Range <b>HO.RE.CA.</b>	Model <b>KORO PRIME – KORINTO PRIME</b>	N° T.I. <b>15_2019</b>
Serial Number <b>93610939</b>	Subject <b>GROUP Z3000 ROTATION LEVER MODIFICATION</b>

**Modified Z3000 rotation Lever**

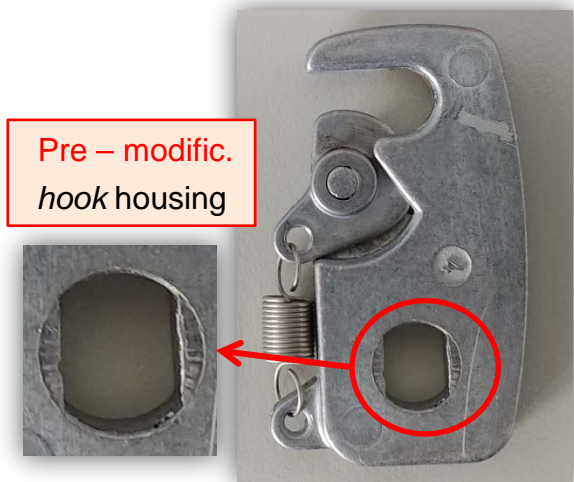
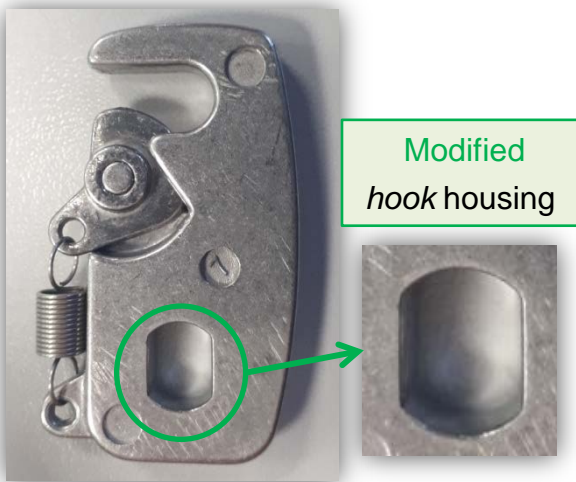
To prevent an incorrect movement of the Z3000 group

The Z3000 group **rotation lever** has been modified: the **hook** housing for Z3000 group has been slightly updated. The lever molding process changed.

For machnes previous to above **S/N** it's possible to use the **modified lever**.

The "Group Z3000 rotation **Lever**" spare code is not changed: **251943**
